Access Compliance Report

Public Rights-of-Way

Intersection ID: N/A	Main Street: TRYON_ST	Cross Street: NEVADA_BV	Location: SE
ADA ID: 0A57A8FCEA7F	Ramp Type: PerpDiag	Initial Pass/Fail: Fail	Overall Compliance: No
Codes/Mitigation Info/Possible Solution		Field Measurements/Component Compliance	
Severity Score: 33.75

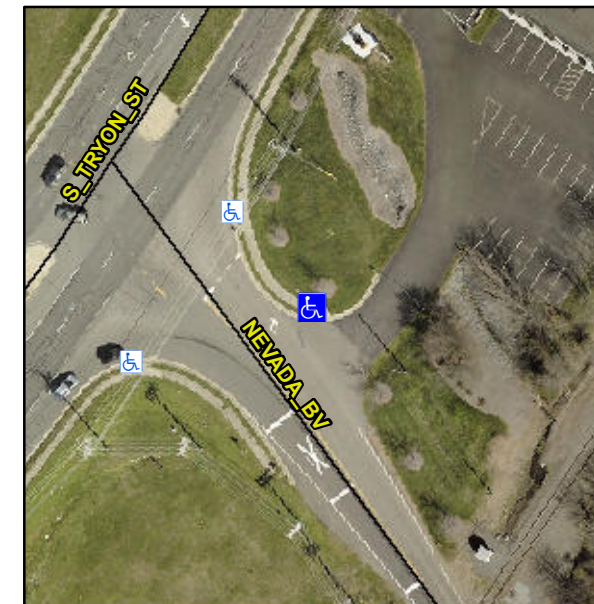
R304.5.1, R304.2.2, R304.5.3

Compliance	Description	Data	Compliance	Description	Data
N/A	Ramp Length (in)	87.0	No	Ramp Slope (%)	10.8
No	Ramp Width (in)	47.0	No	Ramp XSlope (%)	6.3
N/A	Flare Type LT	N/A	N/A	Flare Type RT	N/A
N/A	Flare Slope LT (%)	N/A	N/A	Flare Slope RT (%)	N/A
N/A	Flare Traversable LT?	N/A	N/A	Flare Traversable RT?	N/A
N/A	Landing Length (in)	N/A	N/A	DWS Provided?	N/A
N/A	Landing Width (in)	N/A	N/A	DWS Contrast?	N/A
N/A	Landing Slope (%)	N/A	N/A	DWS Length (in)	N/A
N/A	Landing X Slope (%)	N/A	N/A	DWS Full Width?	N/A
N/A	Landing Curb? (Y/N)	N/A	N/A	DWS Offset (in)	N/A
N/A	Shared Landing?	N/A			
N/A	Gutter Ponding?	N/A	N/A	Gutter Slope (%)	N/A
N/A	Gutter Lip Ht (in)	N/A	N/A	Gutter X Slope (%)	N/A
N/A	Painted X Walk1?	No	N/A	Painted X Walk2?	No
	X Walk 1 Direction	To W		X Walk 2 Direction	To S
N/A	X Walk 1 Width (in)	N/A	N/A	X Walk 2 Width (in)	N/A
	X Walk 1 Slope (%)	0.3		X Walk 2 Slope (%)	5.6
	X Walk 1 X Slope (%)	7.7		X Walk 2 X Slope (%)	0.2

Remove & Replace Curb Ramp With Two New Directional Ramps or Equivalent.
